BOLLETTINO TECNICO

N° **139-085**

SUBJECT: Fire Extinguisher Bottle Assy P/N 3G2620V00131

REASON: some bottles have been found with electrical receptacles installed on wrong outlet ends.

Figure 3

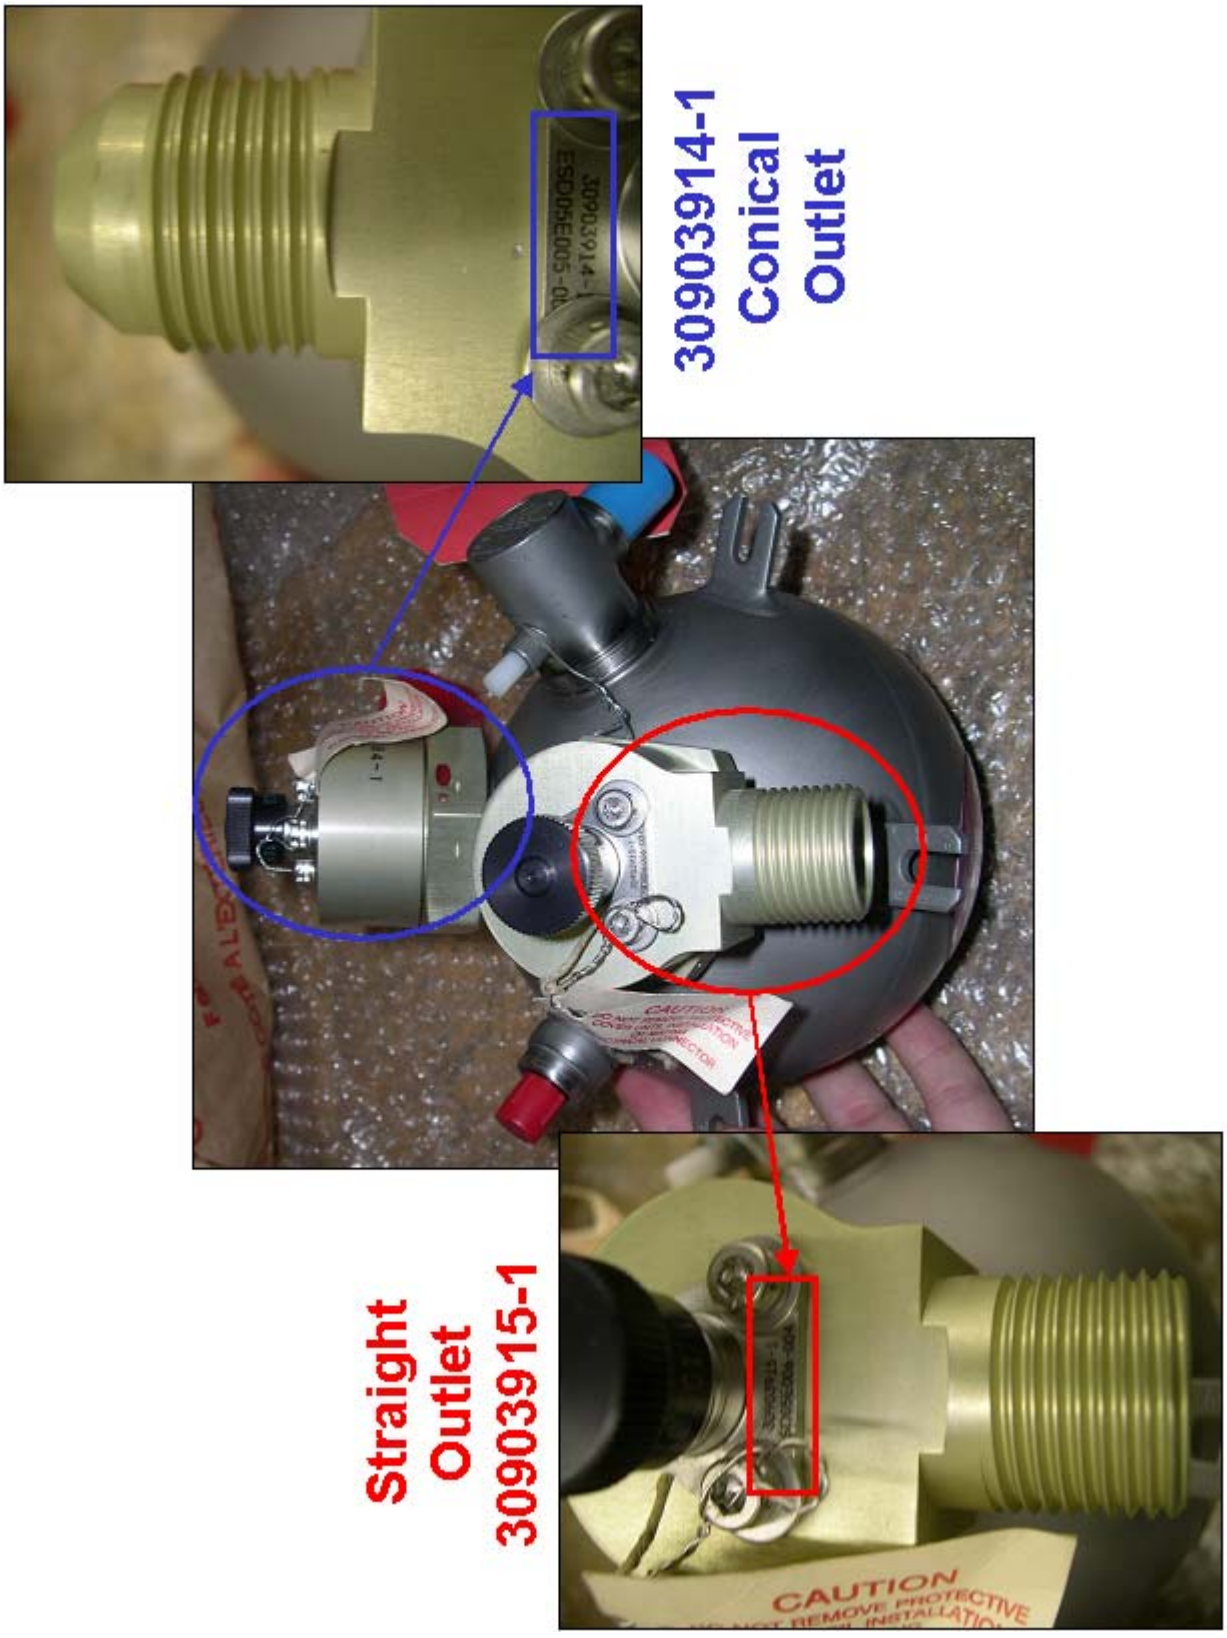
5. With reference to figure 3, make sure that:

a. Receptacle P/N 30903914-1 is installed on outlet end P/N MS33514G12.

Outlet end P/N MS33514G12 is the most distant from the central mounting lug of the bottle assy.

b. Receptacle P/N 30903915-1 is installed on outlet end P/N AS4395G12.

Outlet end P/N AS4395G12 is the closest to the central mounting lug of the bottle assy.

6. If the receptacles are found to be inverted, replace the defective bottle with a bottle P/N 3G2620V00131 having the receptacles in the proper position. Refer to Aircraft Maintenance Publication (see data modules n° 39-A-26-21-01-00A-520A-A and n° 39-A-26-21-01-00A-720A-A for Number 1 fire extinguishing bottle and data modules n° 39-A-26-22-01-00A-520A-A and n° 39-A-26-22-01-00A-720A-A for Number 2 fire extinguishing bottle).

Figure 4

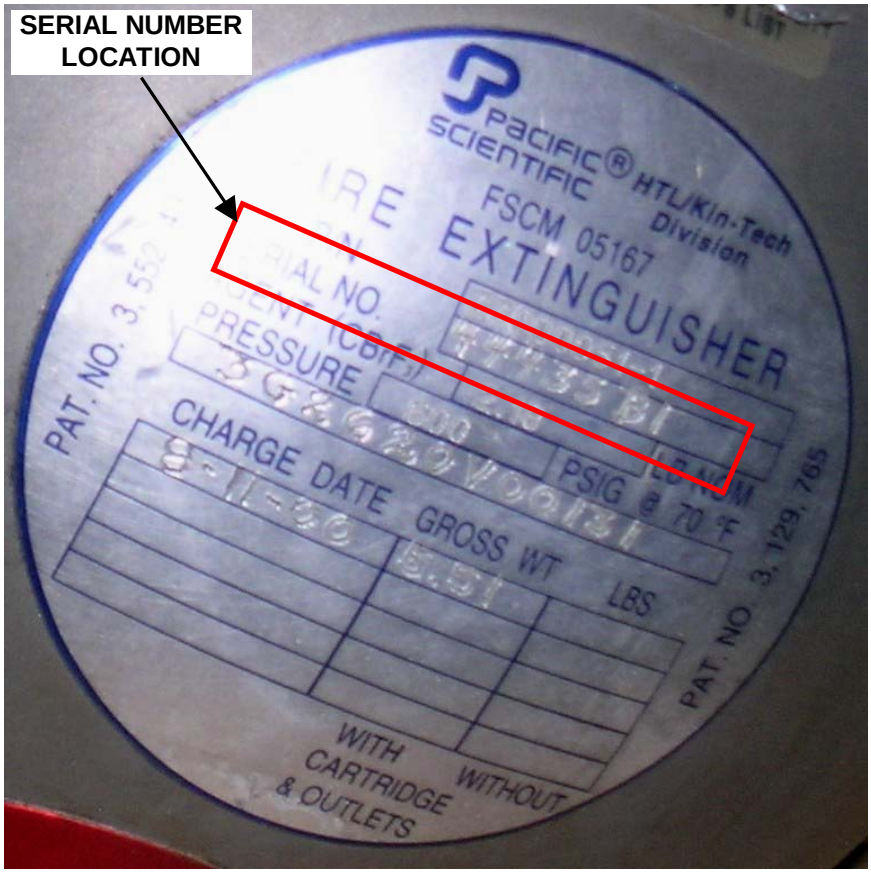
Bottles suspected to have the aforementioned defect are identified with S/N less than 56822B1 (bottle S/N coding is as XXXXXB1 and is located on the bottle placard shown in figure 4).
